Central Coast Local Planning Panel Meeting Business Paper 26 May 2022

Item No:	3.1	Control Coast
Title:	DA 52083/2017(C) Section 8.2 Review - 5-7 Church St, Terrigal	Central Coast Local Planning Panel
Department	: Environment and Planning	
26 May 2022	Local Planning Panel Meeting	
Reference:	DA/52083/2017/C - D15109604	
Author:	Salli Pendergast, Principal Development Planner North

Above: Proposed modified building (left) approved original building (right)

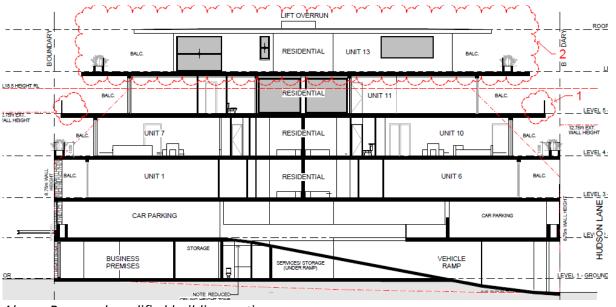
The proposed modifications are considered to materially alter the approved development and will result in a development that will not remain substantially the same as originally approved. While the nature of the development as shop top housing will not be changing, the proposed modifications will materially alter the form and envelope in which the development takes place. The resultant increase in overall height and floor space (outside of the approved building envelope) is considered to result in a radical transformation of the building form and appearance in the streetscape.

The applicant has argued that the modified development is substantially the same development to that originally approved and that the impacts of the change are minimal.

However, the modification is not simply the addition of one unit to the scheme as the applicant would argue. The addition of the "one" dwelling unit is outside the original approved envelope and in a position higher than the approved building roof where visual and other impacts are most acute and differ in magnitude than that of the original development.

Above: Proposed modified building section

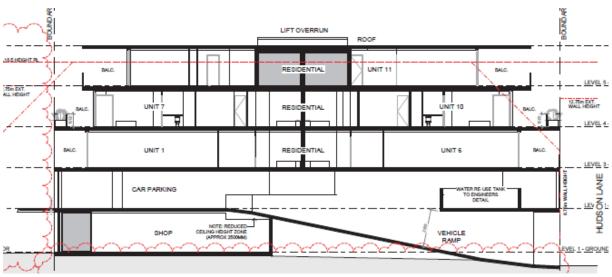
These cumulative changes to the original approved development are considered to result in a substantially different development to that which was originally approved and are considered to alter the essential elements of the originally approved development.

Above: Proposed modified ground floor of development

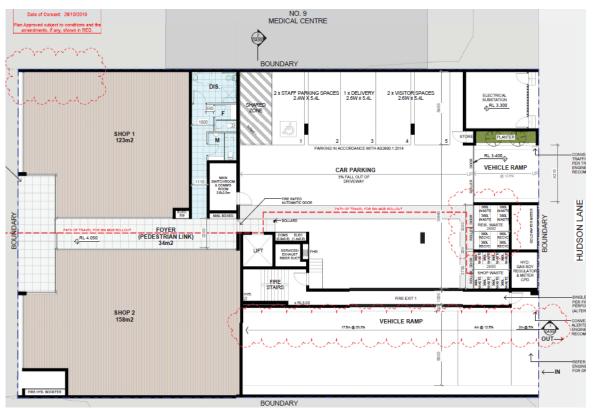
The consequences of carrying out the modified development, compared to the originally approved development, will be noticeable, particularly in relation to view loss and visual impacts. It is considered that the bulk and scale of the development as perceived from surrounding viewpoints from both public and private property will significantly and materially change under the proposed modifications. The scale and external appearance of the proposal are significantly different that originally approved. It is also considered that there are unreasonable and significant direct and indirect impacts resulting from the proposed modifications compared to the original development.

Above: Objector's image: Level 4 (unit 11 standing) Approved (green); modified (red) extent of change (white).

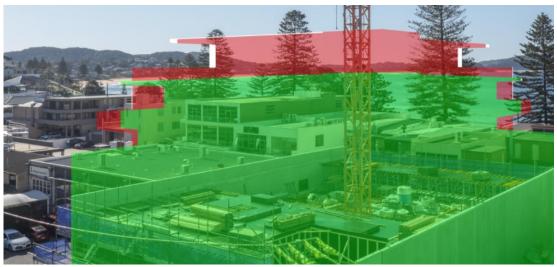
The objector has prepared a view loss report (prepared by Azure) to illustrate the extent of view impact on their property and four images from the report are included below with the approved development shown in green, the proposed additional floor level (penthouse unit) shown in red (refused under the modification) and further changes proposed to the proposed modification under the s8.2 Review application shown in white.

Above: Applicant's 'indicative' image under Appendix A of the views available either side of the development

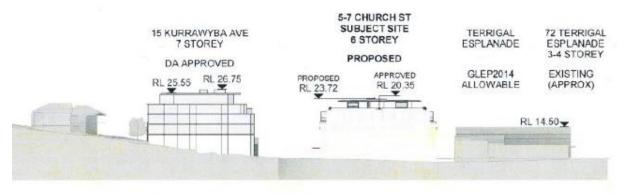
The objector contends that the applicant's 'indicative' panoramic photomontage images above are misleading and that essentially the integrity of the whole view currently afforded at No.15 has not been maintained under the proposal. The proposed amendments to the street and side boundary building setbacks and the reduced floor plate of the proposed penthouse on the subject land under the review does very little to address the original concerns raised regarding view impacts and view loss.

As outline above, the LEC principle states: A development that complies with all planning controls would be considered more reasonable than one that breaches them. Where an impact on views arises as a result of non-compliance with one or more planning controls, even a moderate impact may be considered unreasonable. In this instance, the impacts to views and view loss are created by a modified development proposal that is a direct consequence of a further non-compliance with the GLEP planning control for height that applies to the site. Therefore, the impacts of the proposal are considered unreasonable and are not supported.

Above: Shadow diagram midwinter at 9am

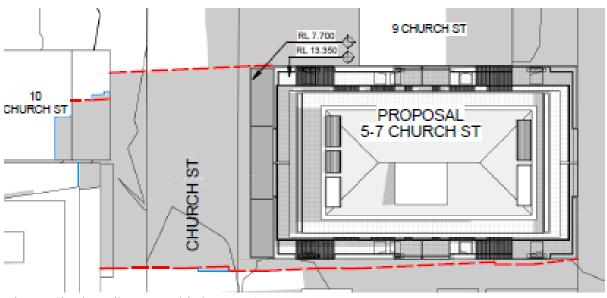
The applicant has provided shadow diagrams to identify the additional shadowing resulting from the proposal at midwinter, equinox and mid-summer. The diagrams indicate the extent of additional overshadowing impacts resulting from the additional level to the building. This includes additional shadowing of Church Street between 9am and 3pm and although the extent of additional proposed shadowing in itself does not appear significant (due mainly to the large extent of shadowing impacts from the approved building on the site), any additional shadowing to the public domain and to surrounding properties is undesirable and not reasonable.
